**FINAL DRAINAGE REPORT
FOR
MC CLINTOCK STATION LOT A
(VOLLMER ROAD RV STORAGE)**

**June 2022
Project No. 25251.00**

**Prepared By:
JR Engineering, LLC
5475 Tech Center Drive
Colorado Springs, CO 80919
719-593-2593**

Revise to PPR-2245

EXISTING DRAINAGE MAP
VOLLMER RV STORAGE
JOB NO. 25251.00
06/23/2022
SHEET 1 OF 1

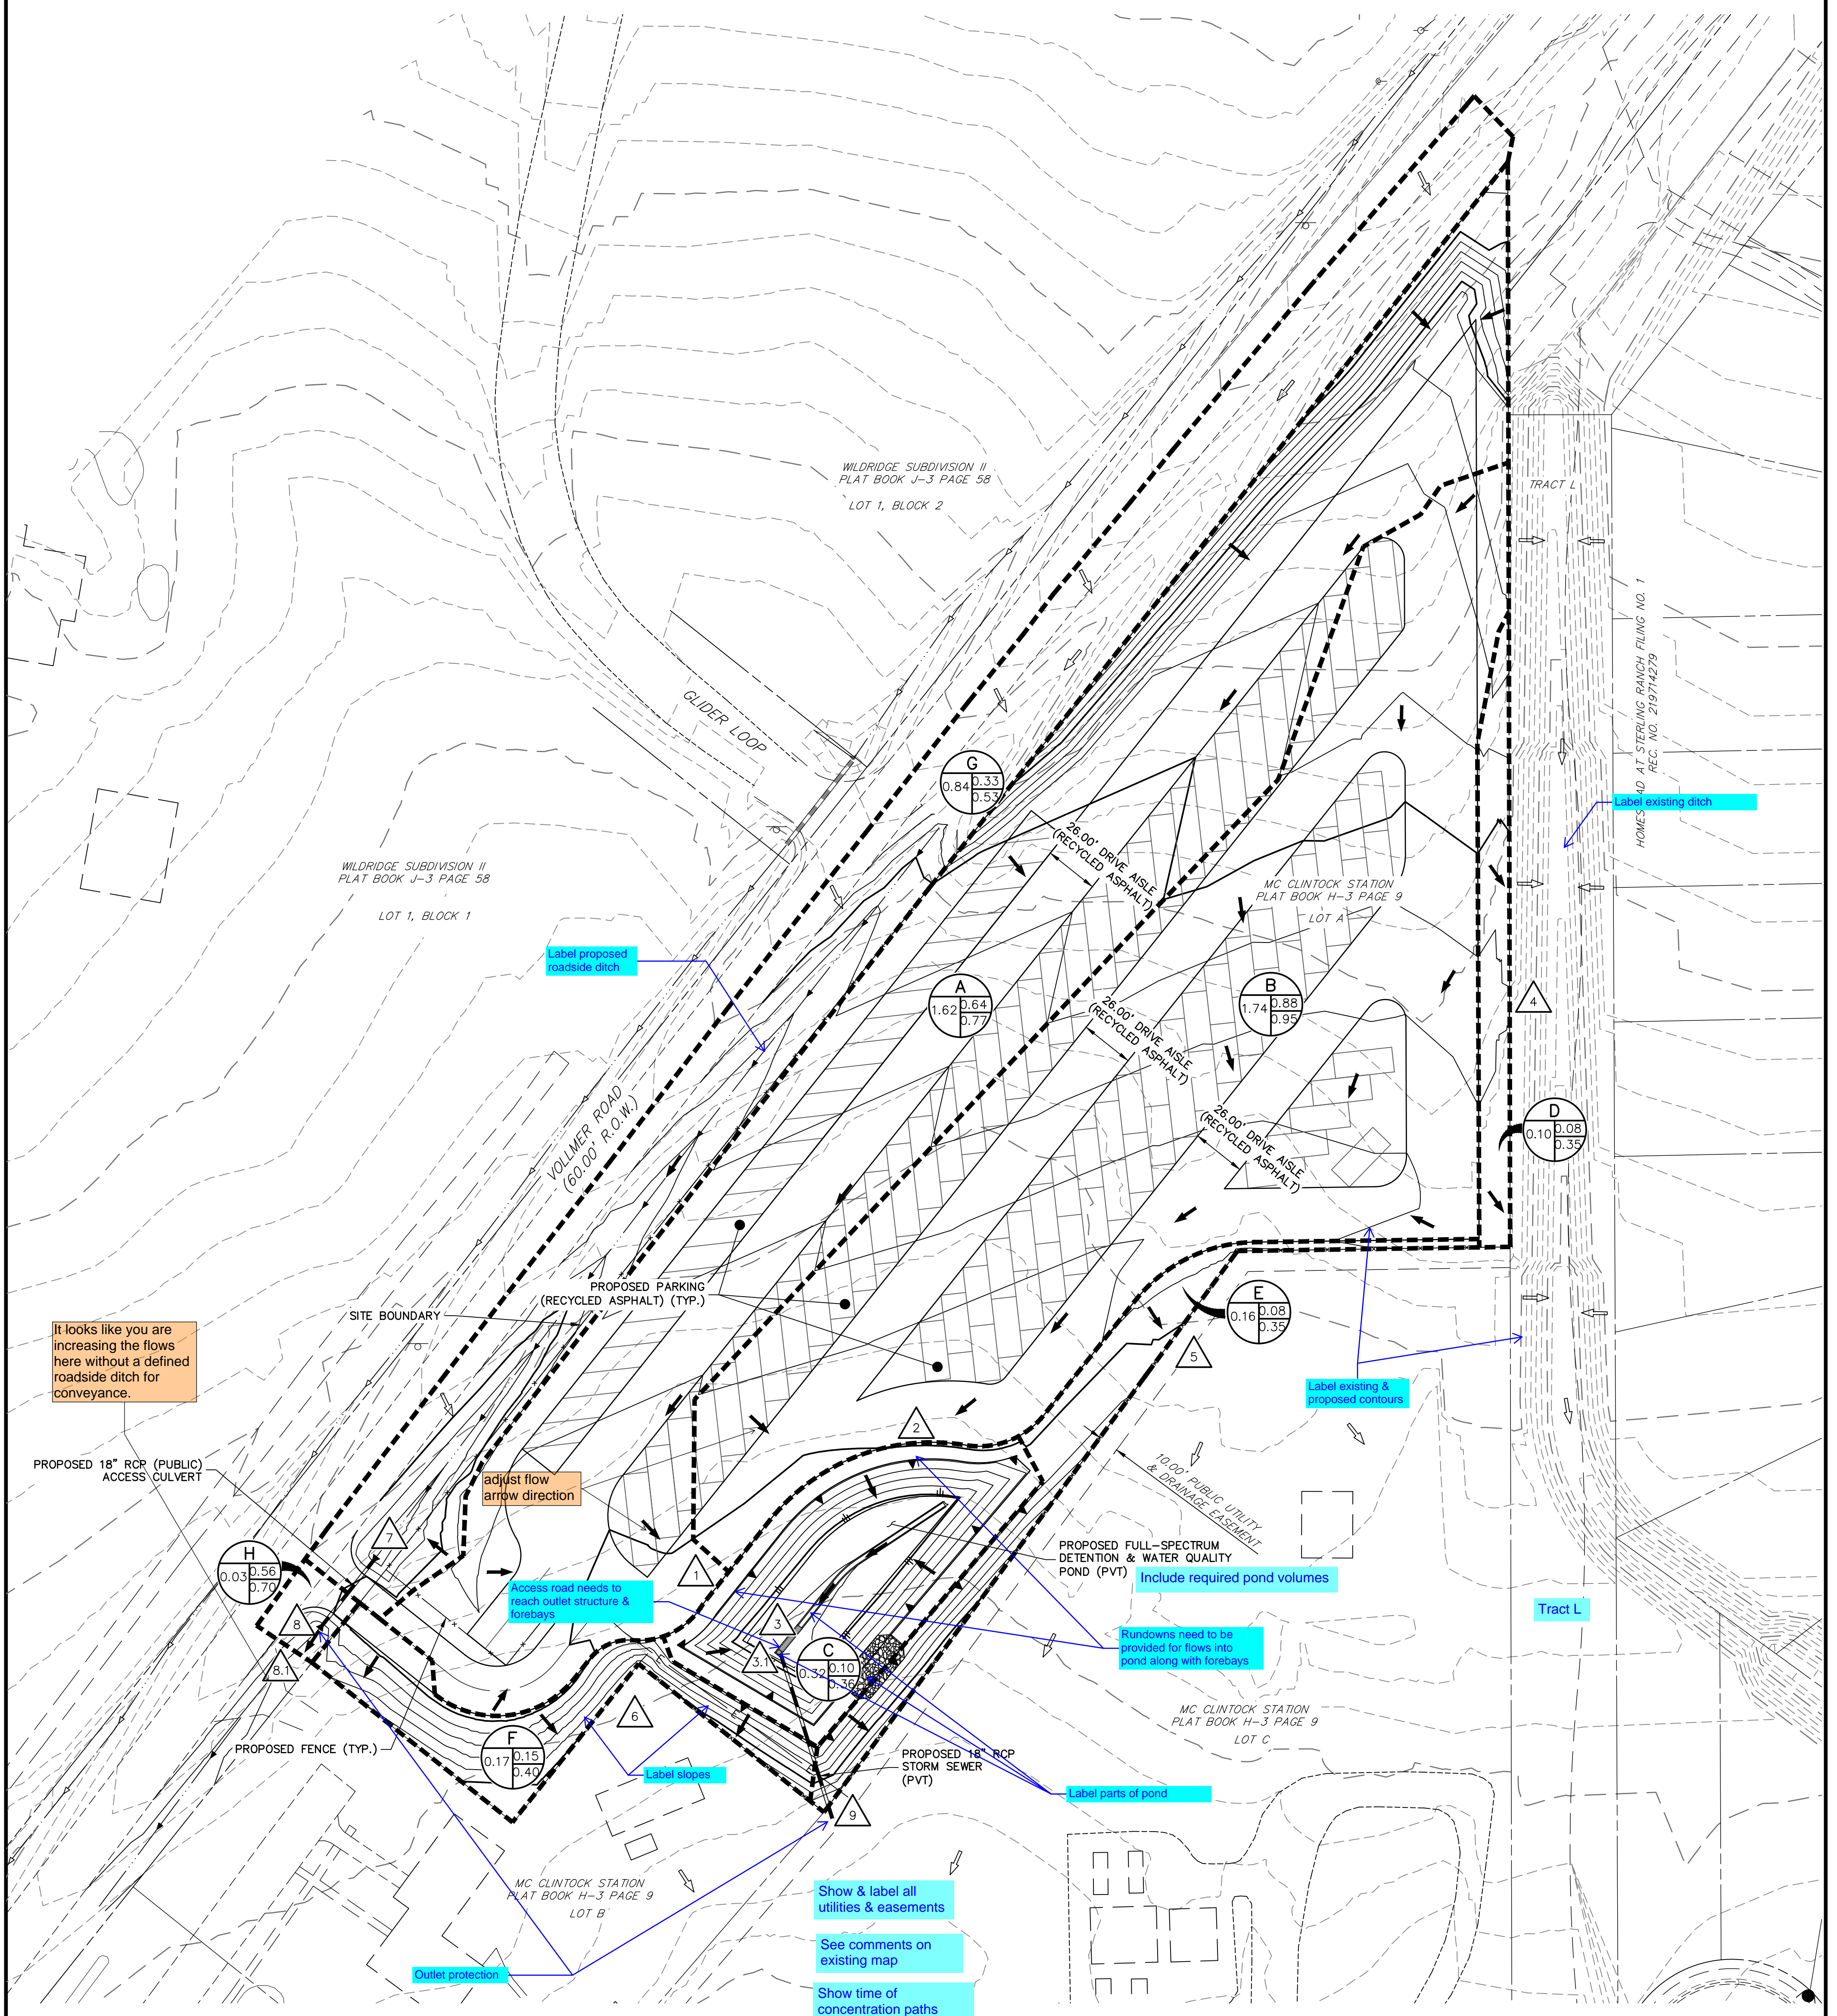
Show and label all existing utilities

What is this line? Label or remove

Show time of concentration paths
